Addendum No. 2

Project No.: 21046

Project: **Courtice Mixed Use Seniors Development at 1697 Highway # 2
RH GAY HOLDINGS COMPANY**

The following information supplements and/or supersedes the bid documents issued on September 10 2024

HOLD DOWN ANCHOR (HDA)
1:10

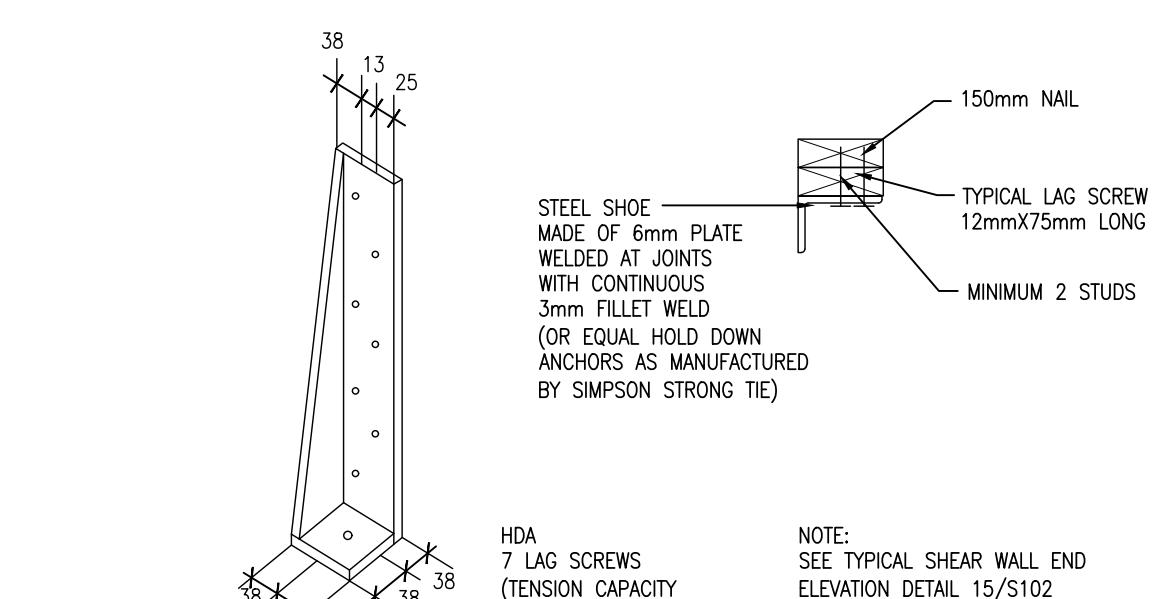
- .1 Hold down anchor embedment specified on Detail 15/S102. Refer to BBA Drawing No. S102 dated September 3, 2024.

FOUNDATION PLAN

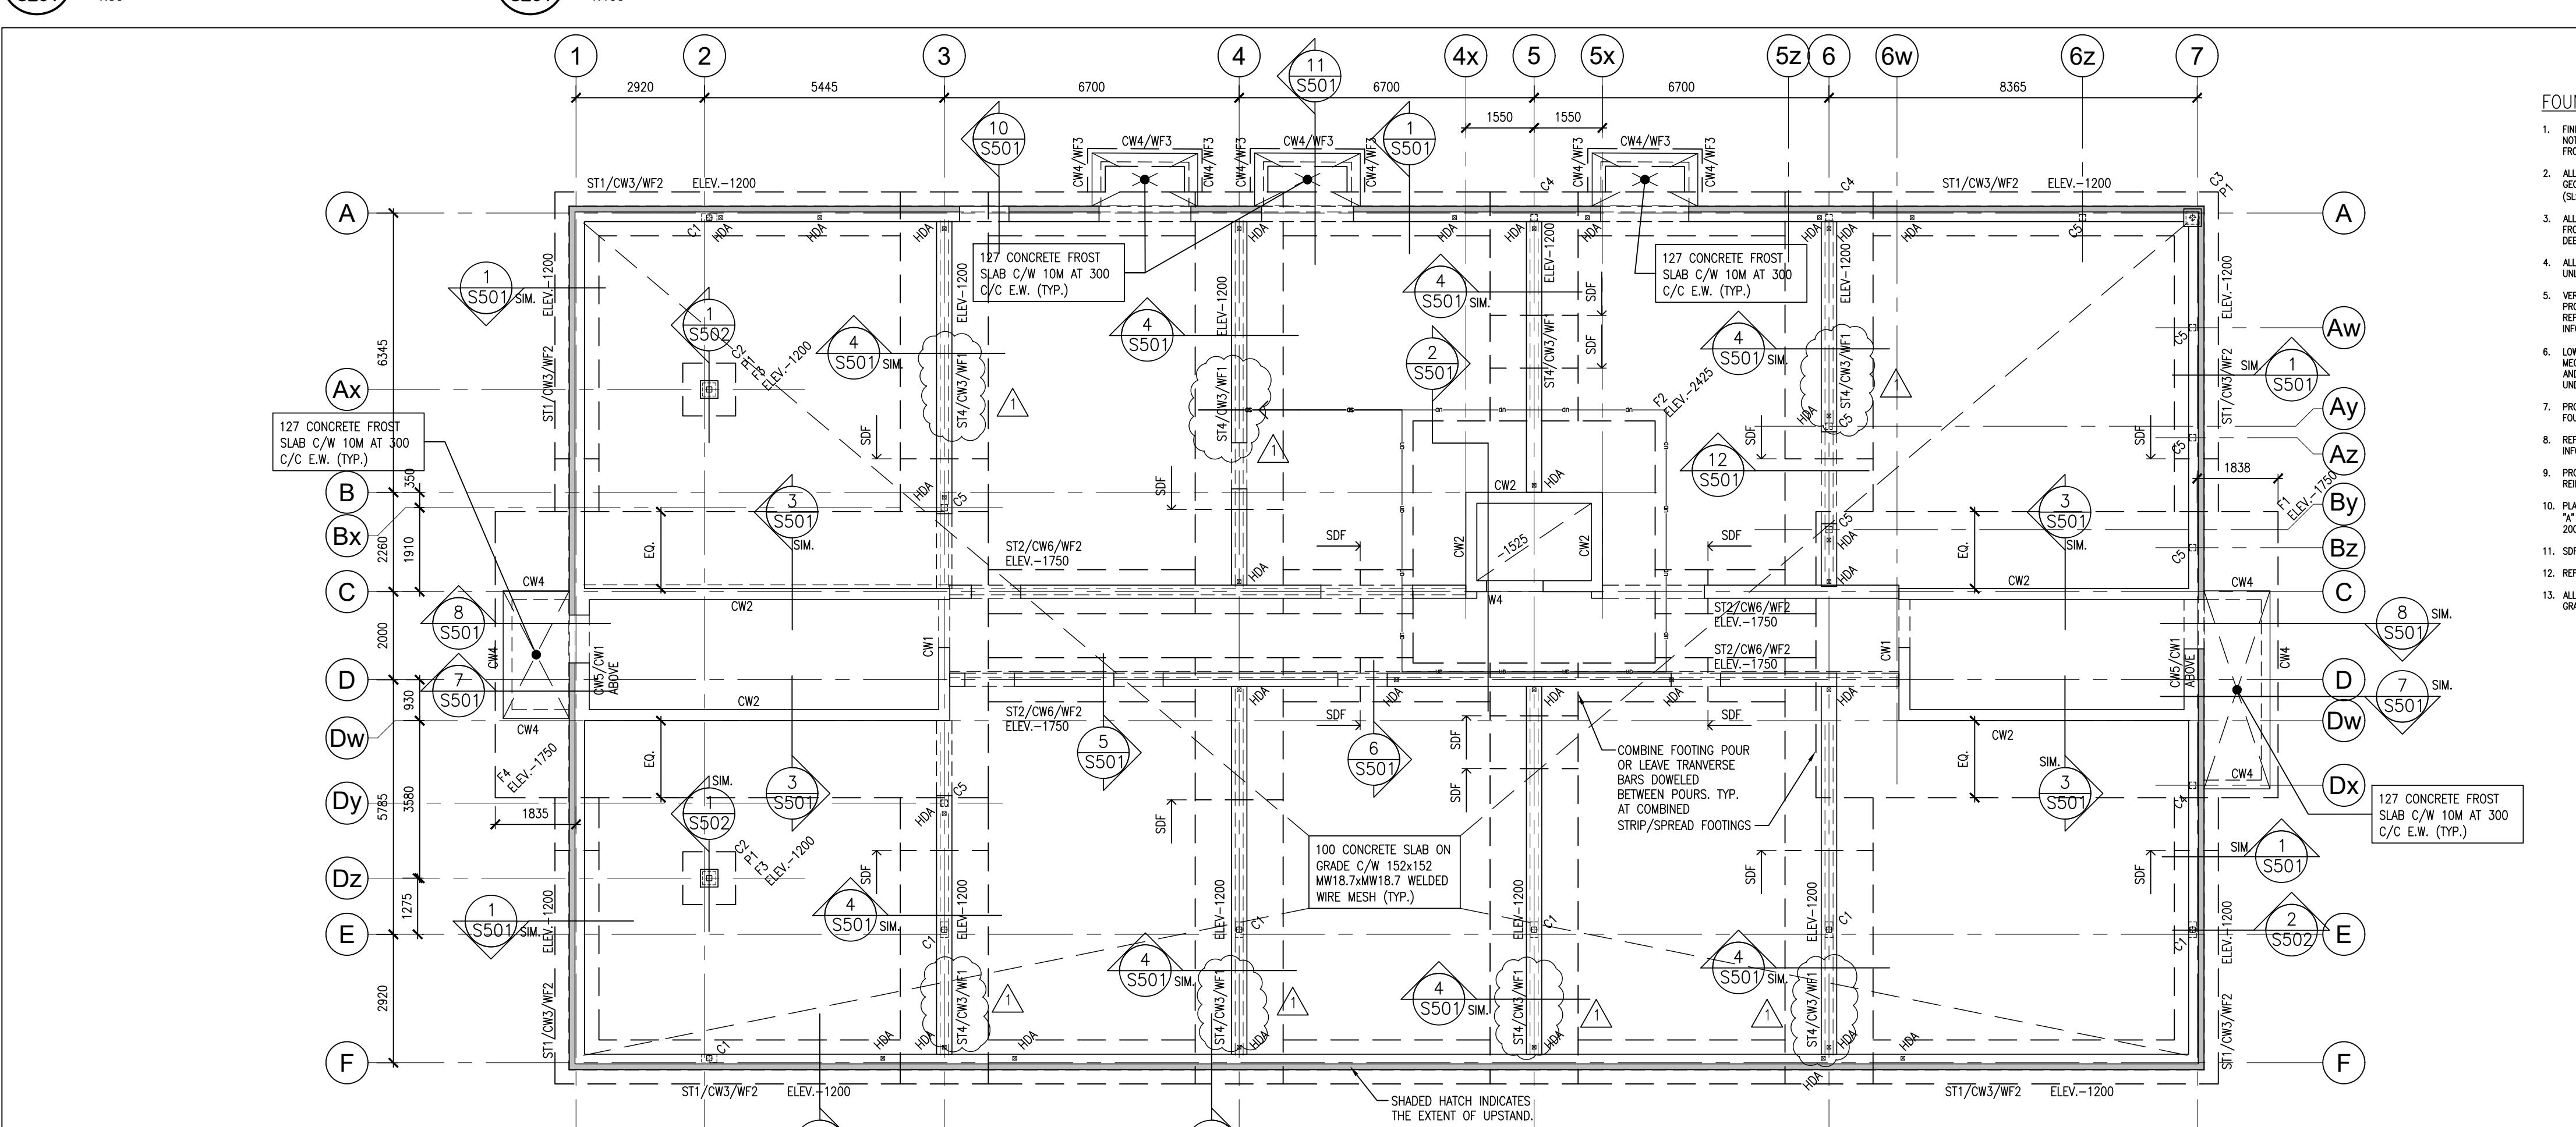
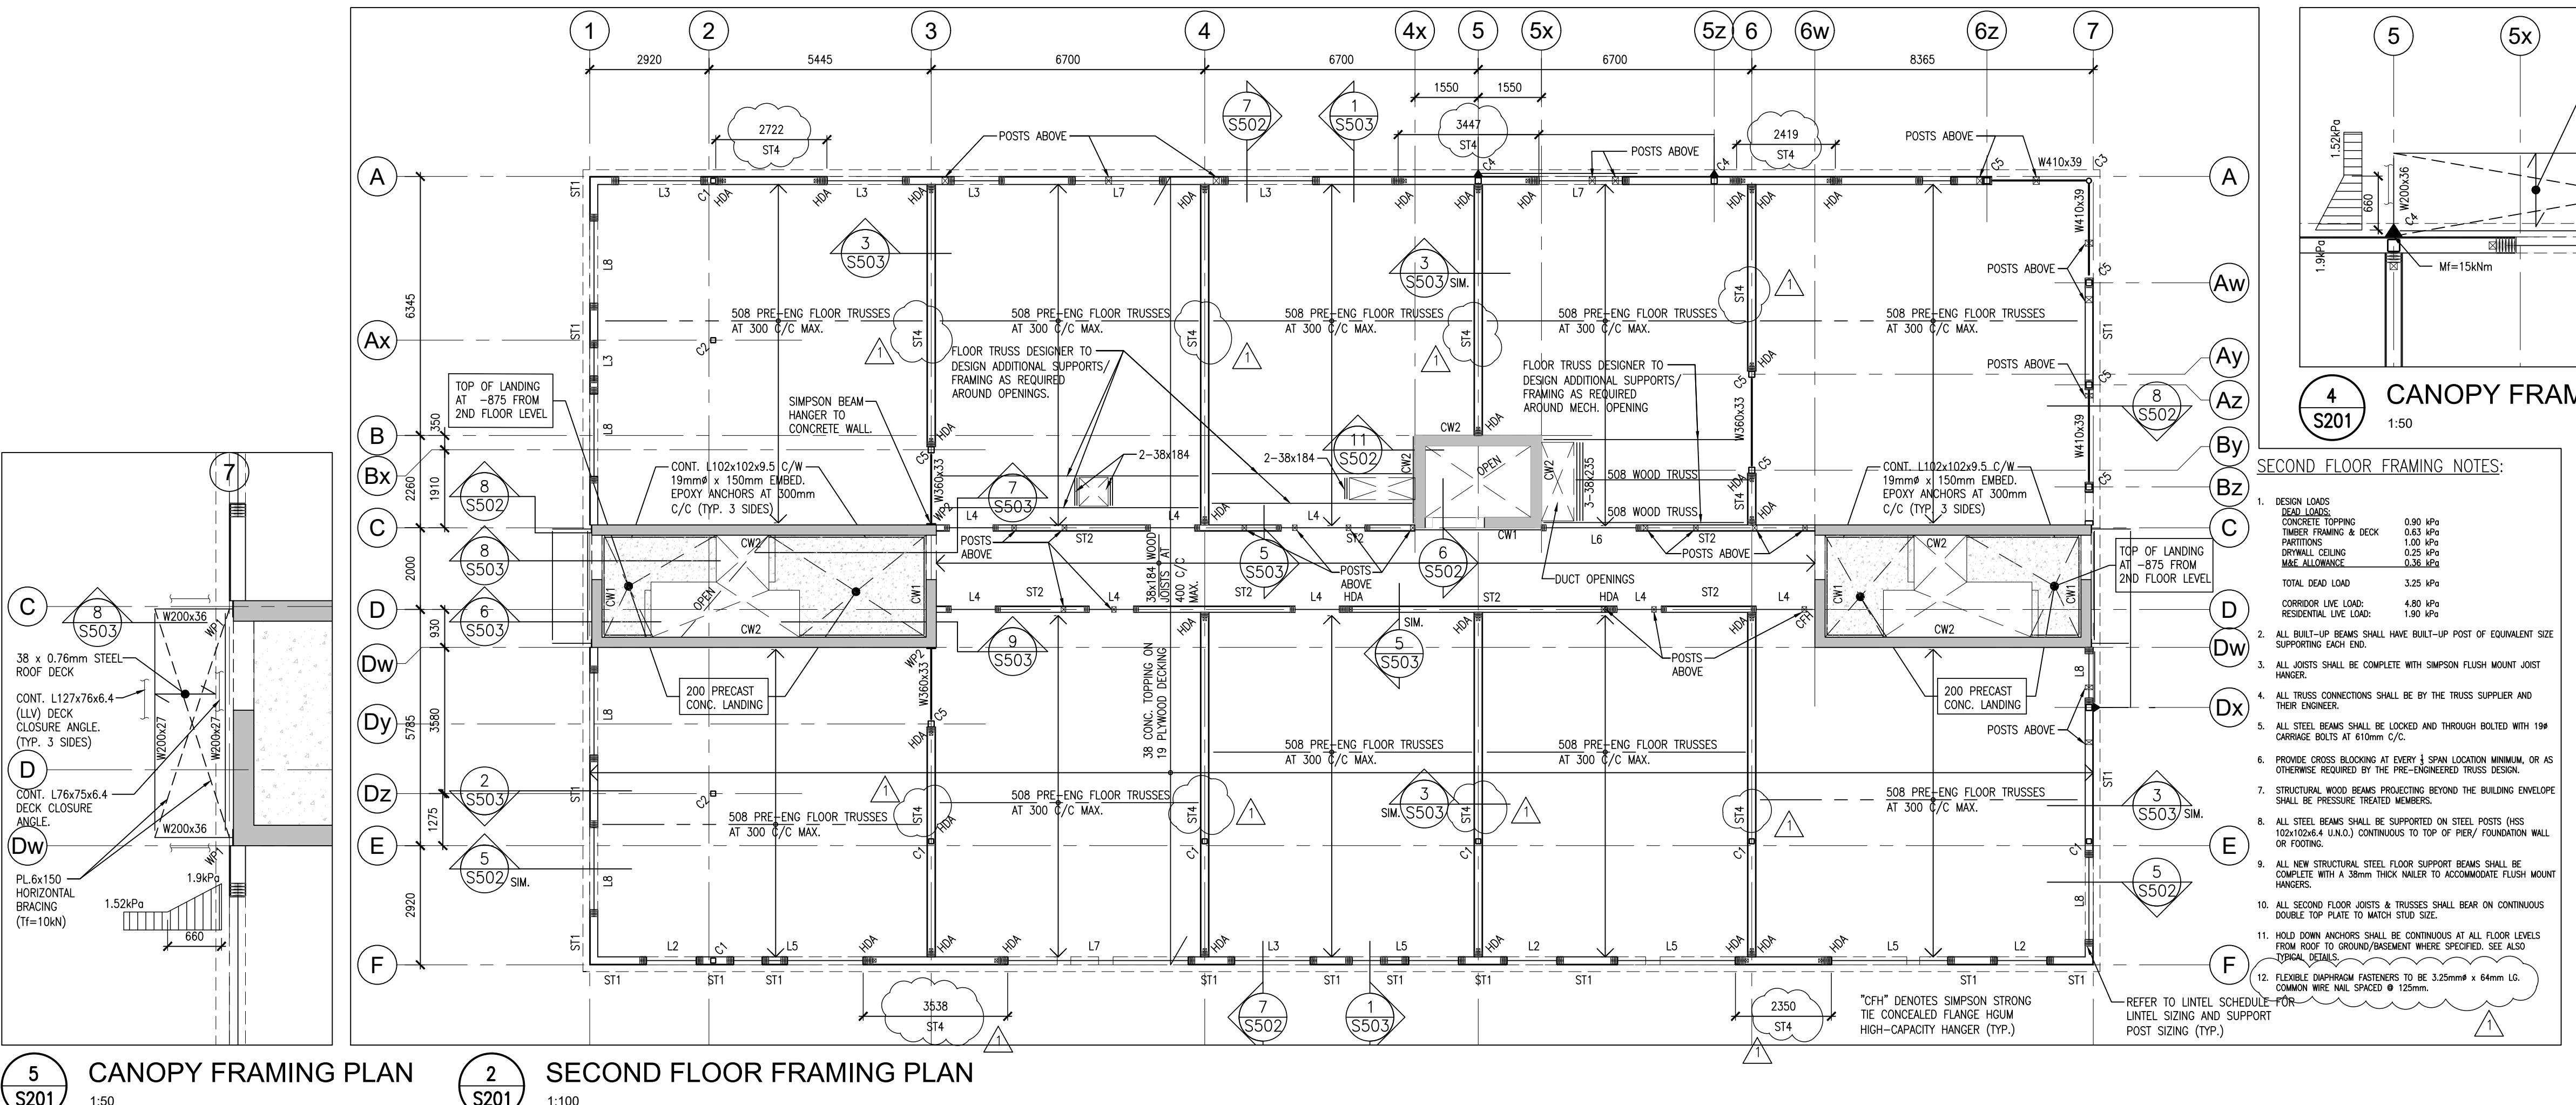
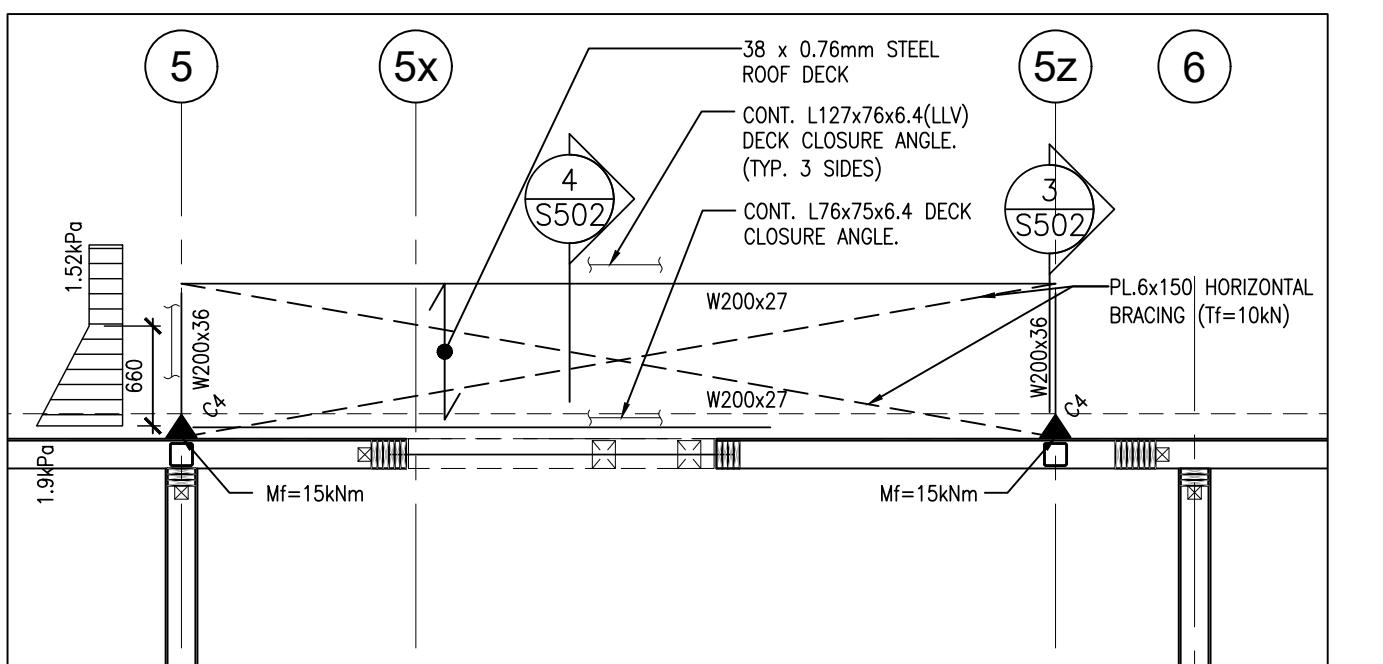
- .1 Shear wall 'ST4' tagged on 1/S201 and 2/S201. Flexible diaphragm fasteners specified under Framing Notes on 2/S201. Refer to BBA Drawing No. S201 dated September 3, 2024.
